**Community Environmental Response  
Facilitation Act (CERFA) Report  
Fort Wingate Depot Activity  
Gallup, New Mexico**

**U.S. Army Environmental Center  
Response to Regulatory Comments  
Fort Wingate Depot Activity Draft CERFA Report**

**U.S. Army Environmental Center  
Response to Internal Army Comments (Requested by the State of New Mexico Environment Department)  
Fort Wingate Army Depot Activity Draft CERFA Report**

PARKING  
AREA

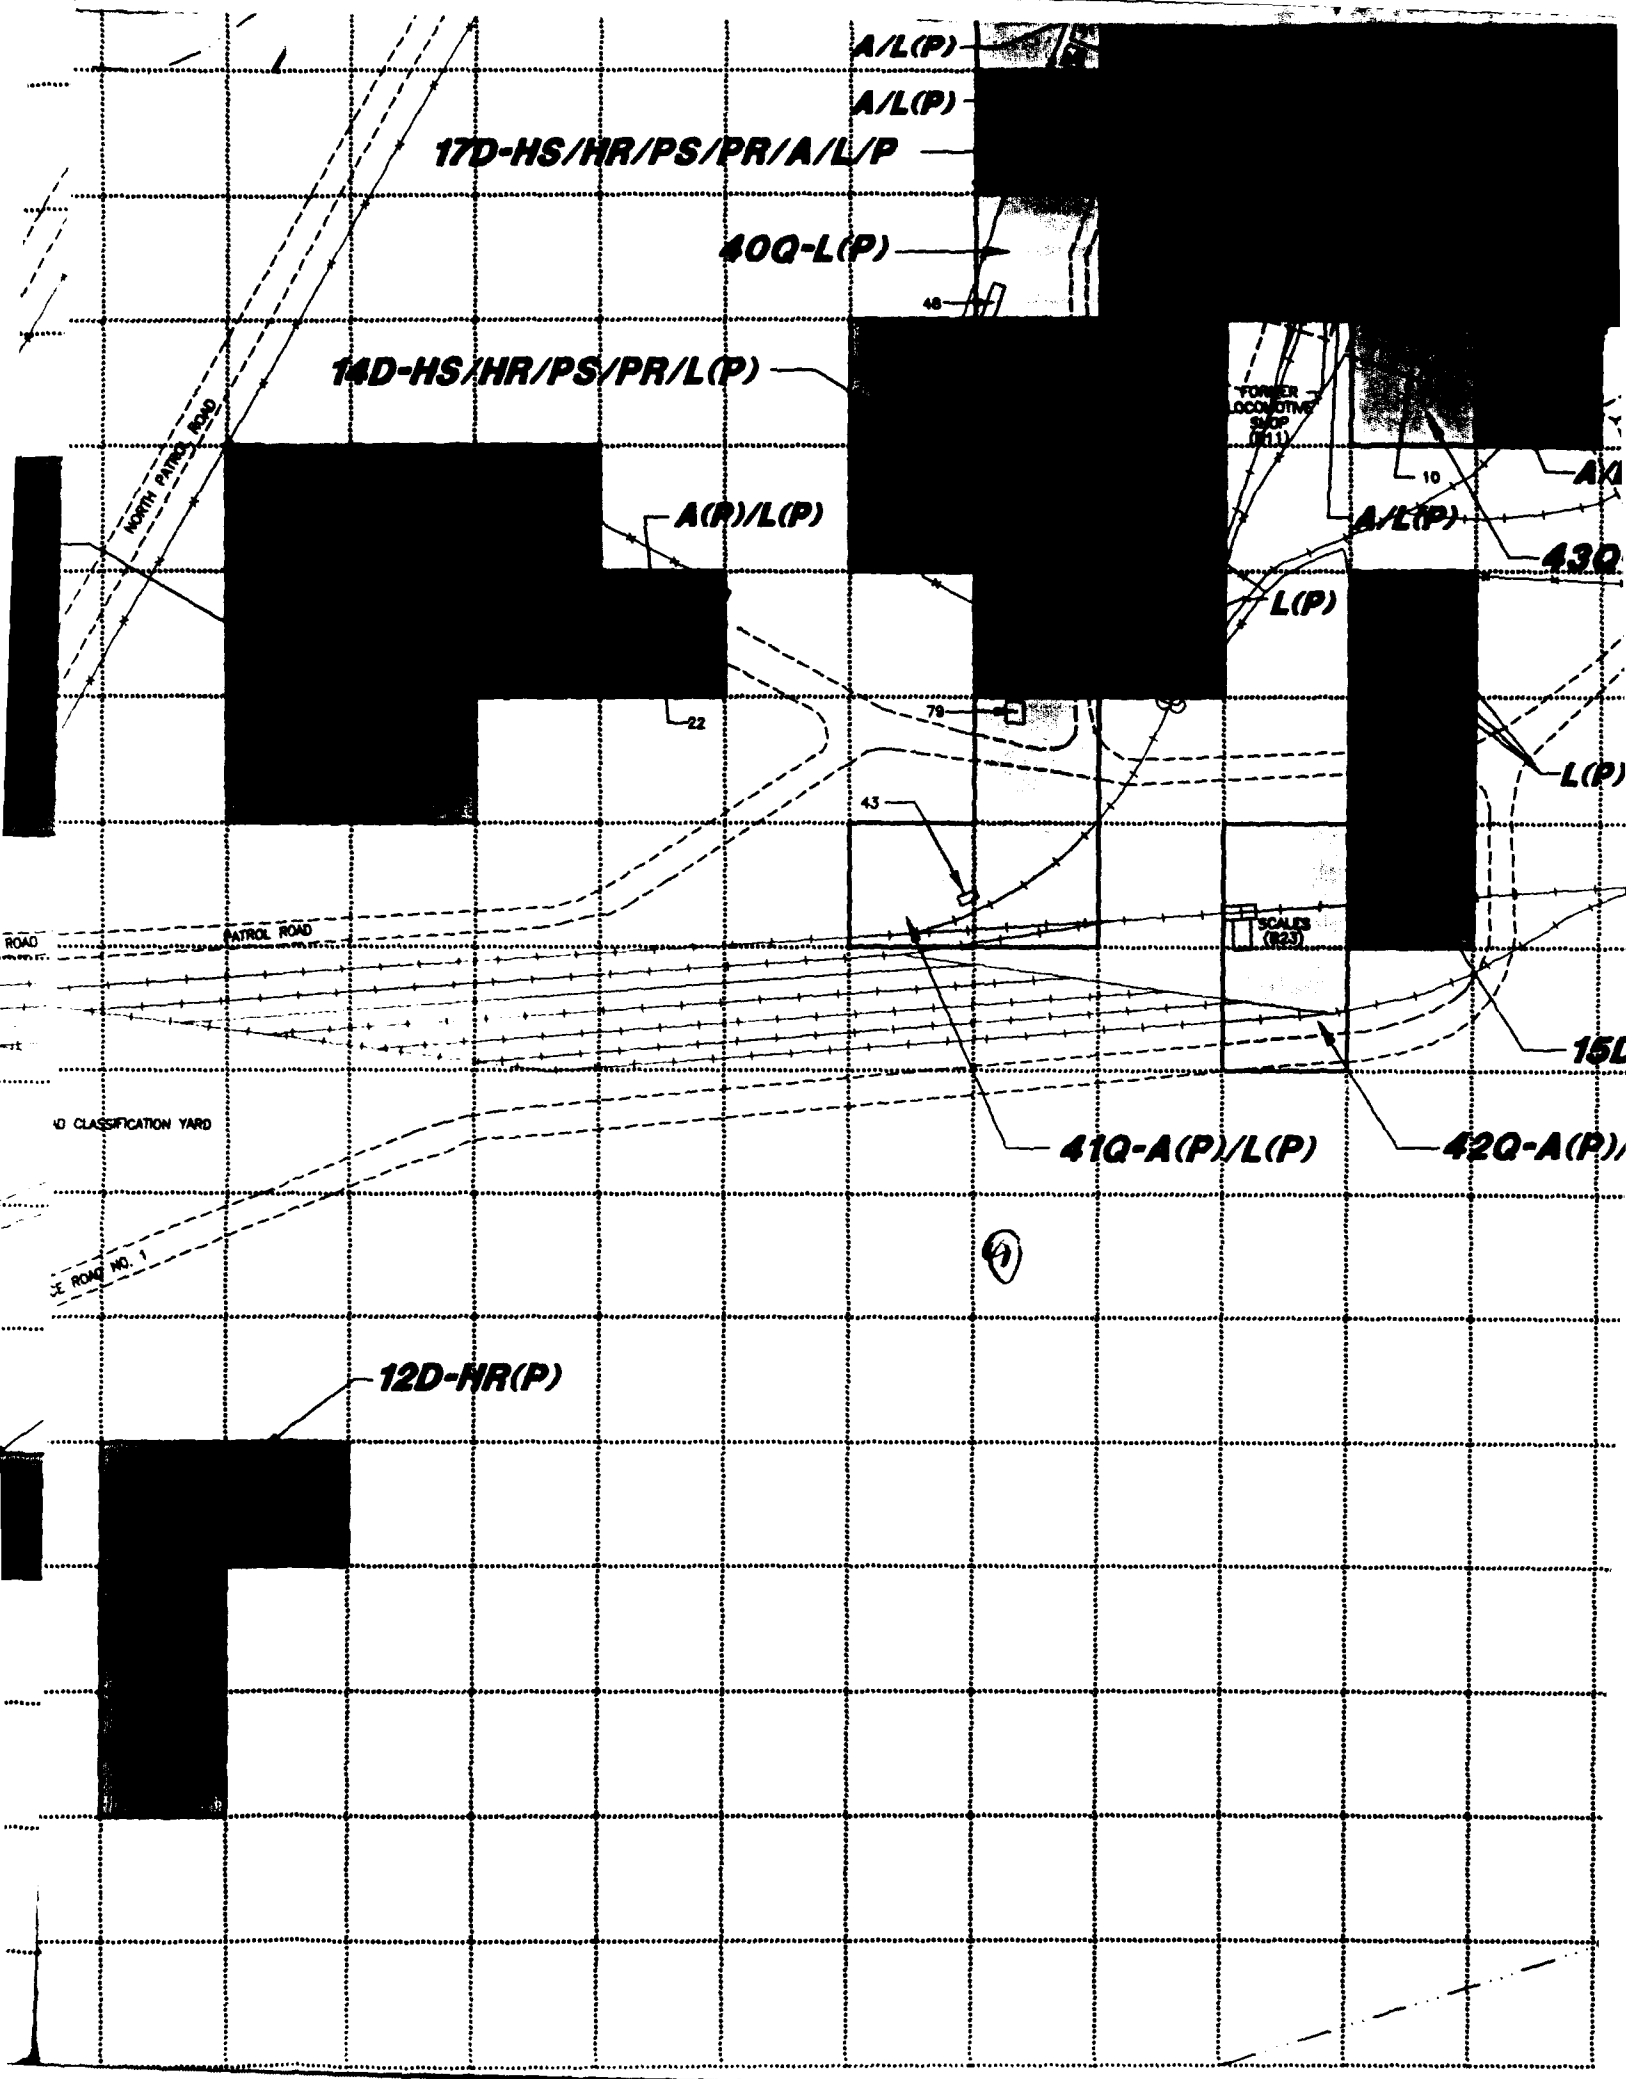
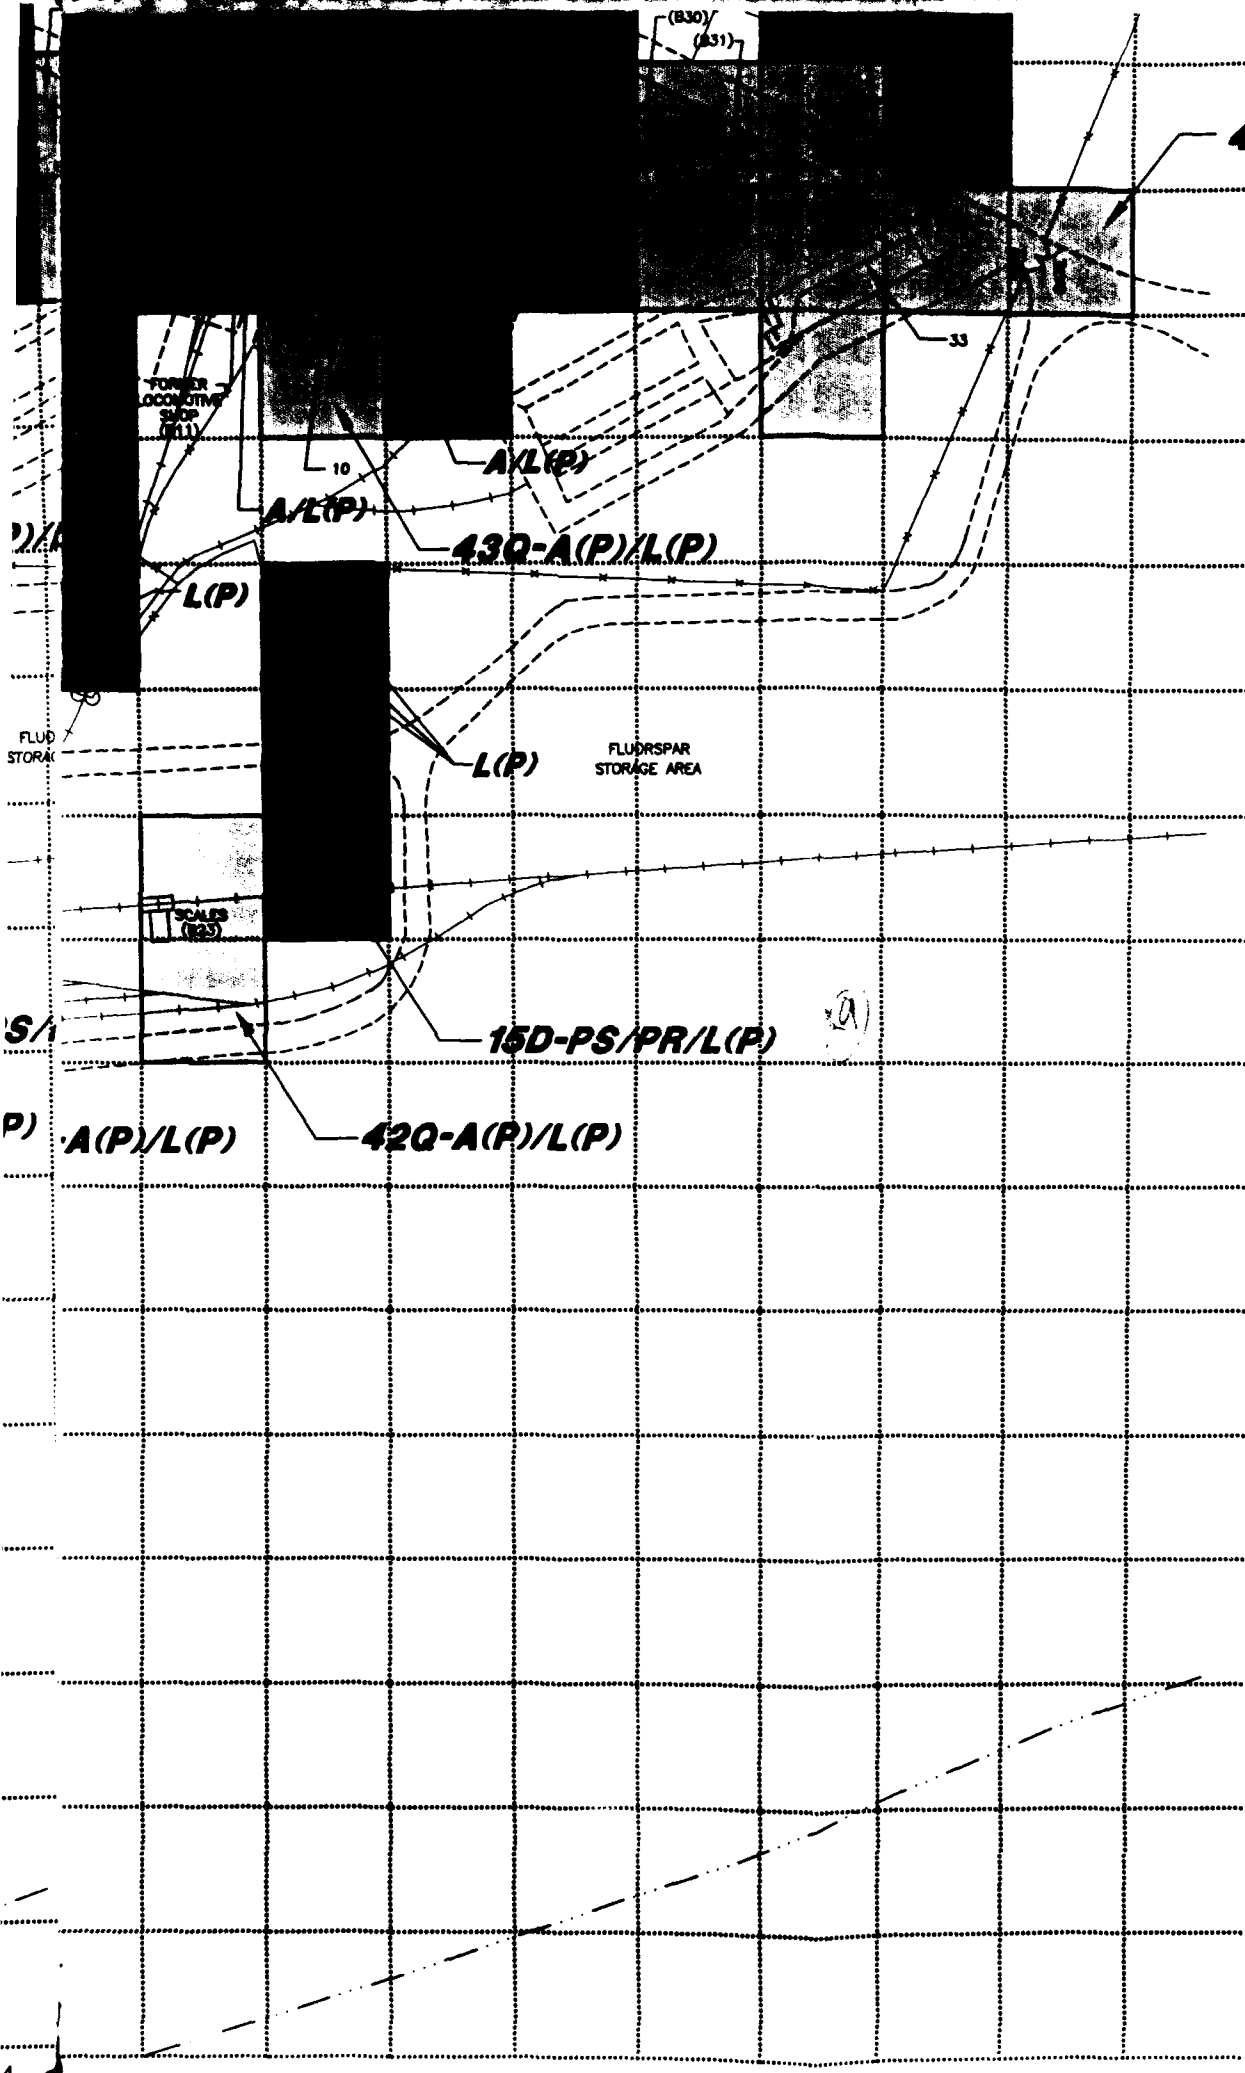
- You must classify the fluorspar storage area found on Sheet 3 of 4. In addition, you fail to acknowledge the buildings in the Administration Area currently under lease for Native American food distribution services. Given the category definitions for this investigation, doesn't this area qualify as a CERFA Excluded parcel? Coordinate with the RI/FS team for this information.

- Sheet 3 of 4 needs to be revised to accurately represent the data from the RI/FS Report.
